Re: Application for Site Plan Review and Special Permit  
102 Howe Street, Ashland Landfill  
Response to Peer Review Comments

AMEC Massachusetts, Inc. (AMEC) is pleased to provide the following responses to comments received from the Town of Ashland's consultant, GCG Associates (GCG), in a letter dated February 8, 2016. GCG's comments are included for reference and AMEC's responses follow each comment.

## ASHLAND LANDFILL 907 KW SOLAR PV DEVELOPMENT ASHLAND, MASSACHUSETTS JANUARY, 2016 ISSUED FOR SITE PLAN REVIEW REVISED FEBRUARY, 2016

DESIGNED BY: NAB  
CHECKED BY: DET  
PROJECT NUMBER: 3652150029  
DRAWING NUMBER: S-502  
SHEET NUMBER: 8 OF 8

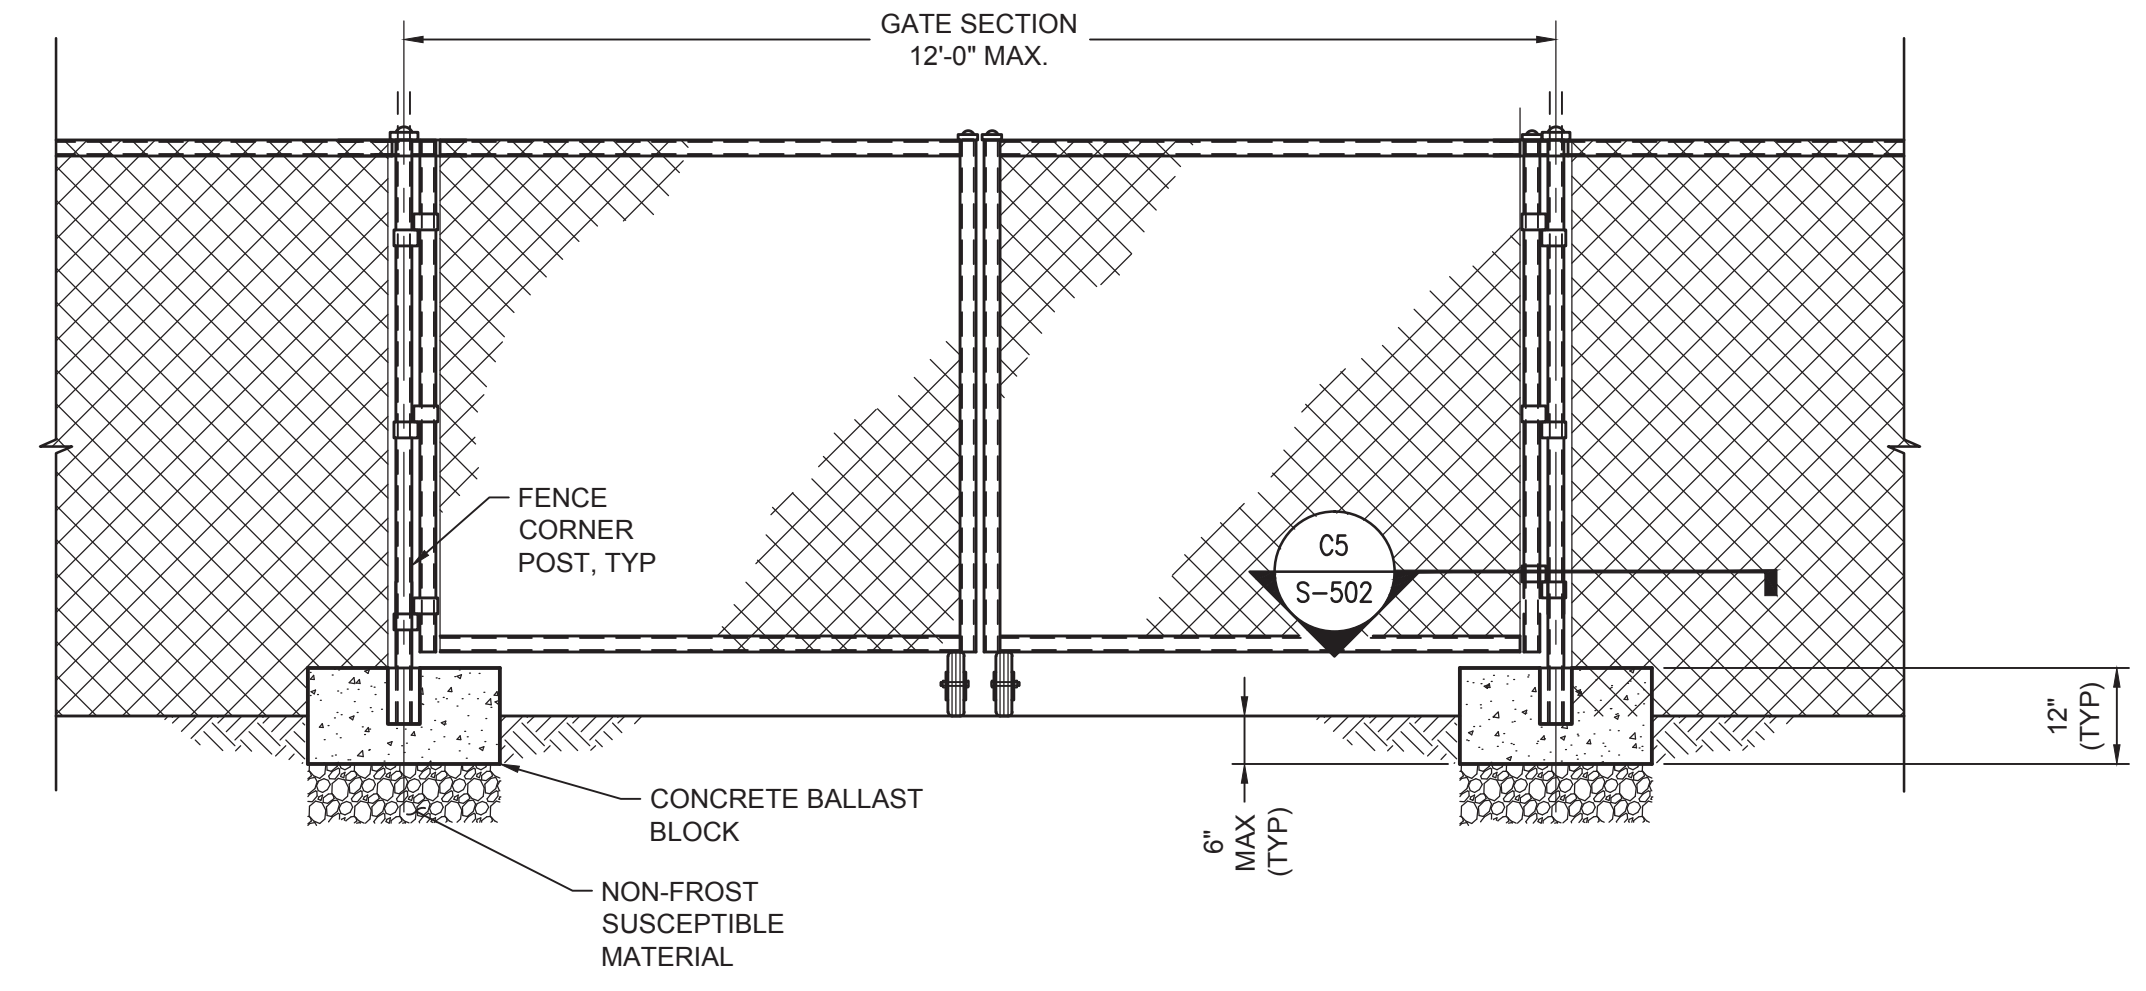
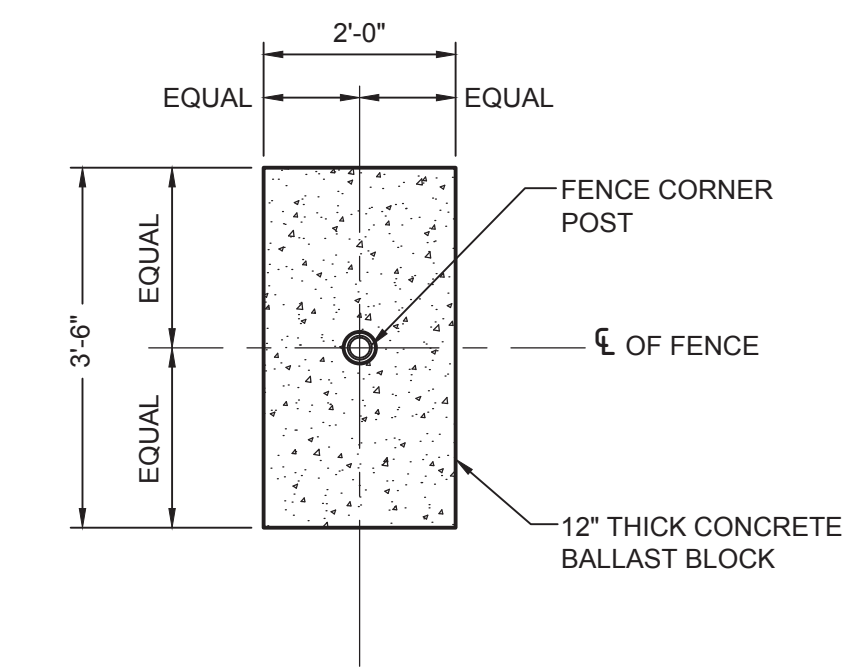
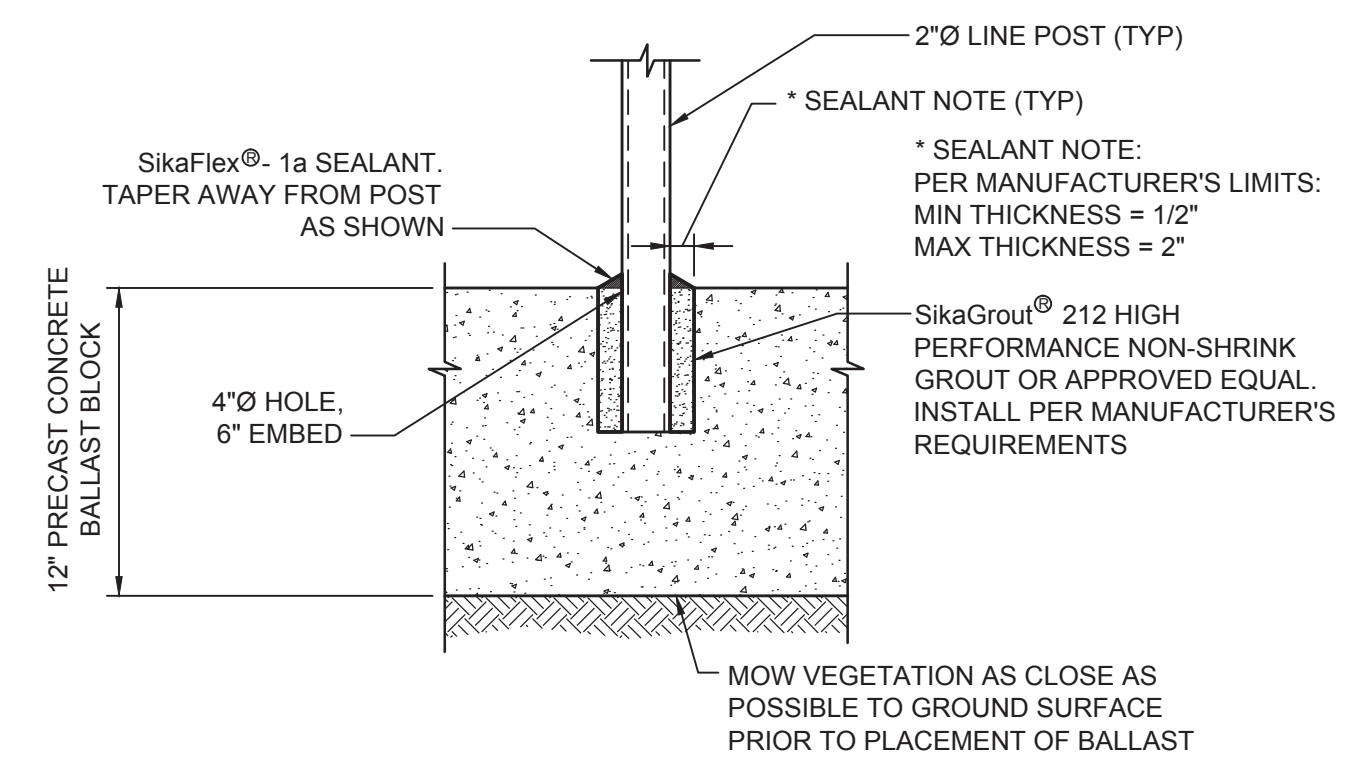
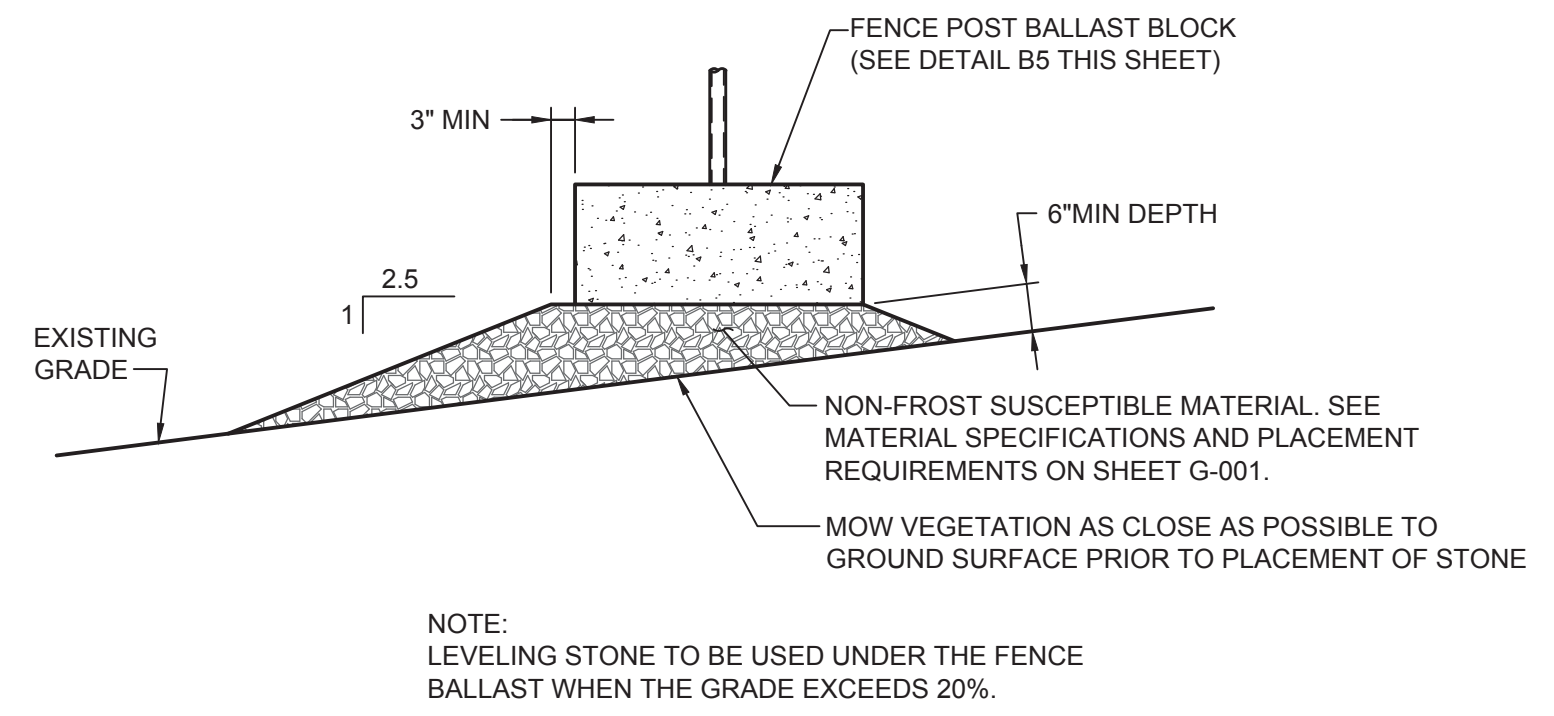
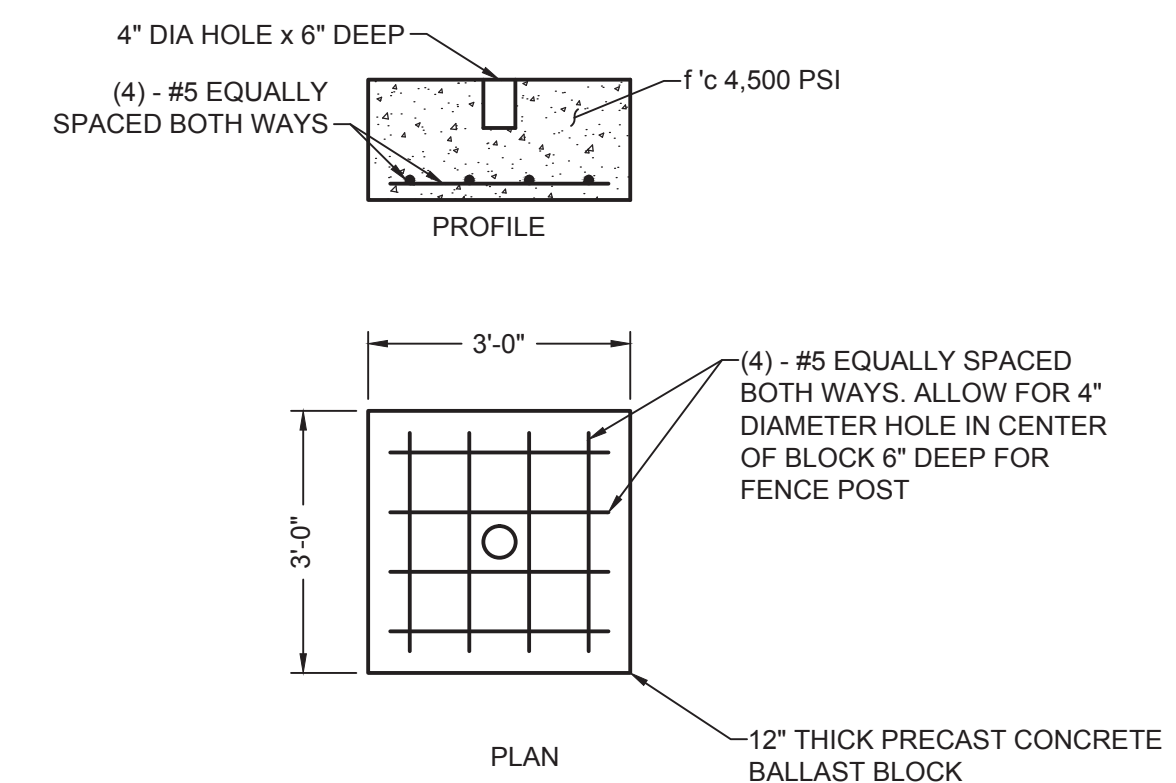
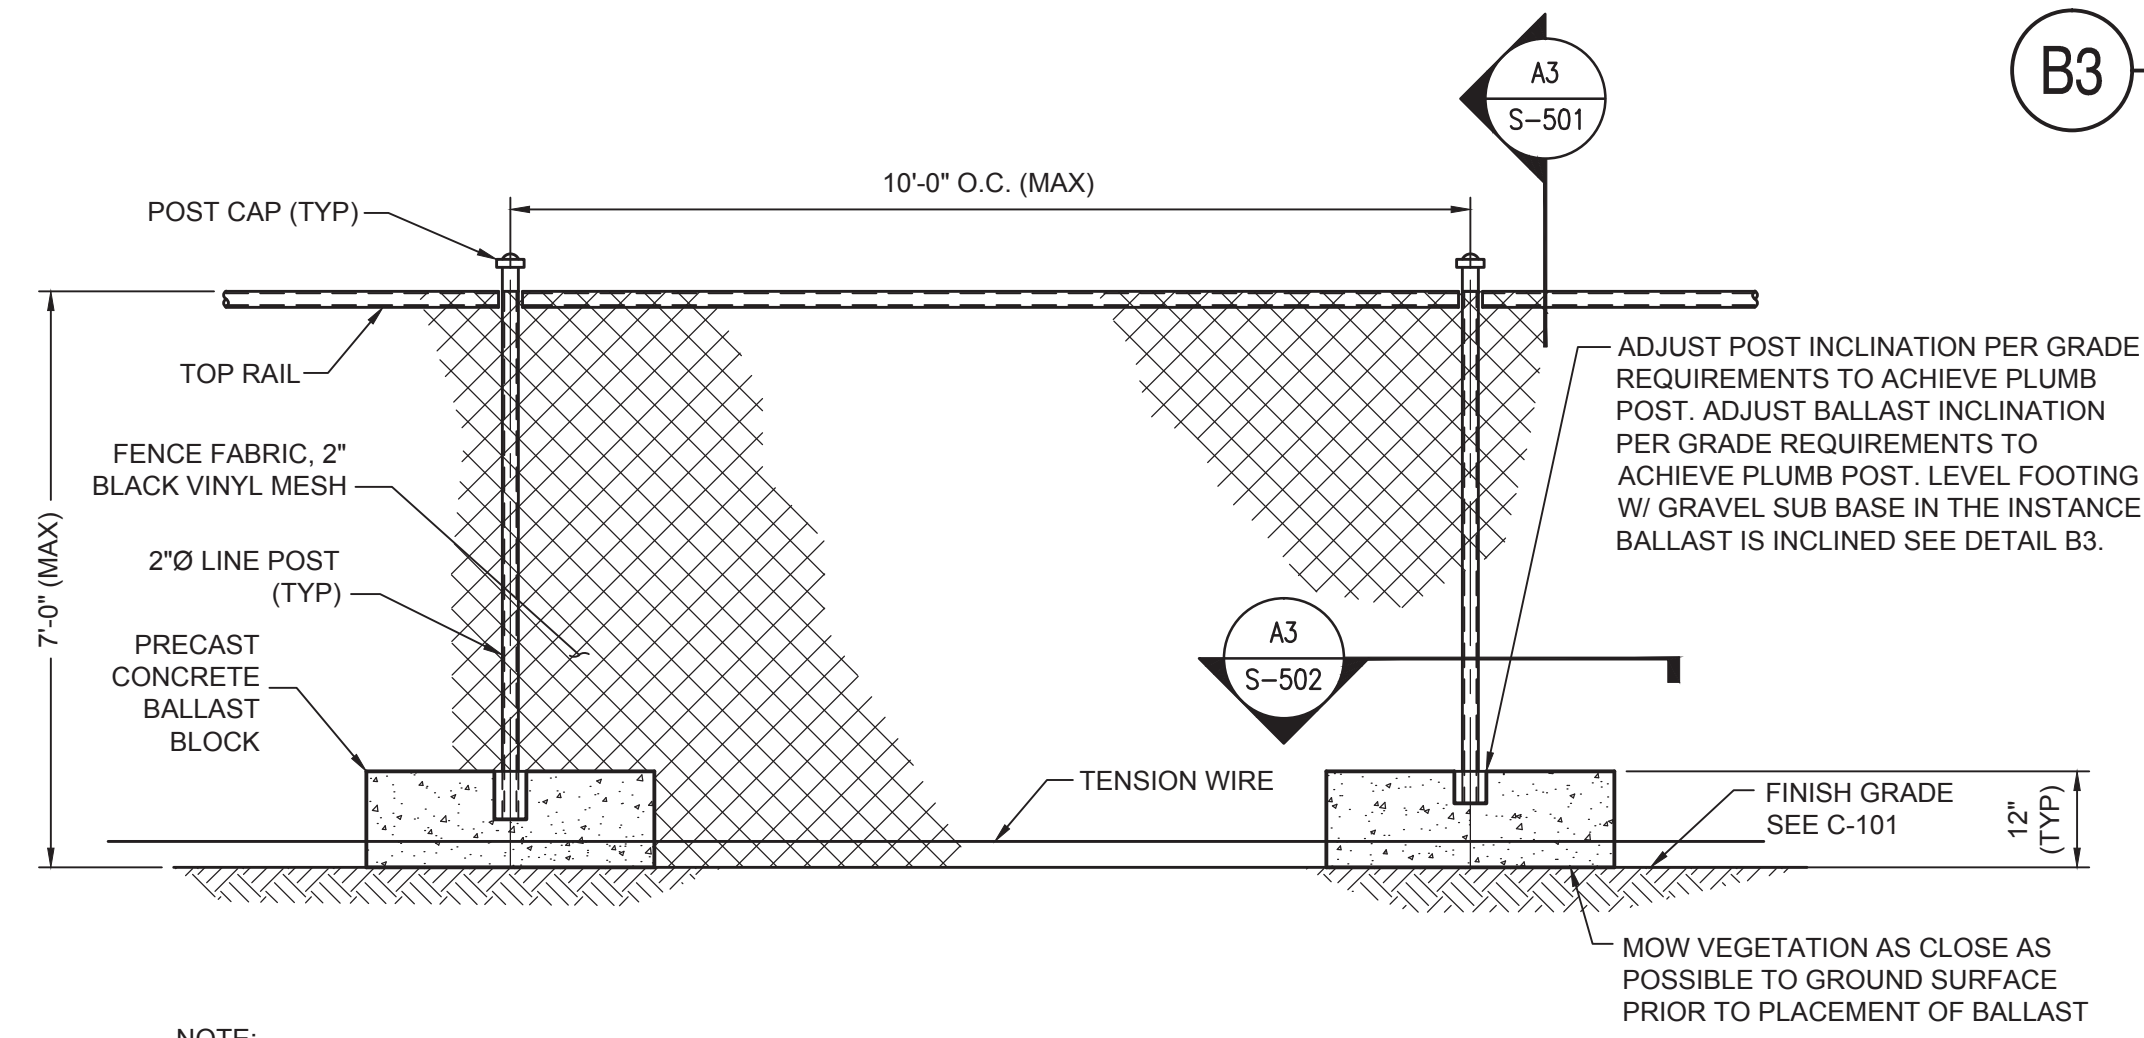
4. Detail 8, Chain Link Fence – Precast concrete ballast block dimensions should be specified and sized to support the fence and fence post system. The dashed line through the ballast block and the ground surface should be clarified and dimensions should be labeled to assure no penetration through the landfill cap. Gate width should be specified.

**Engineer's response:** Additional structural details for the precast ballast blocks and fence gate have been added on a new Sheet 8. The blocks have been adequately sized to structurally support the fence and post system, and the plans are stamped by a licensed structural engineer.
